FIRE SAFETY INSPECTION REPORT

**MANAMI FASHION LTD.
KABIRPUR, ASHULIA, SAVAR**

ACCORD
on Fire and Building Safety in Bangladesh

April 16, 2014

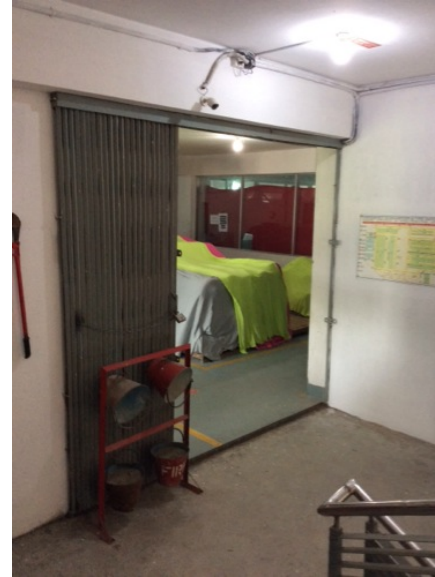
| No. | Category | Finding | Recommendation | Remediation Timeframe |
|-----|-------------------------|--|---|-----------------------|
| F-1 | Fire Rated Construction | Unsealed penetrations and openings are located on the ground floor of the south western exit stair enclosures. | Seal all penetrations and openings in exit stair enclosure walls to maintain the fire separation. | Within 3 months |
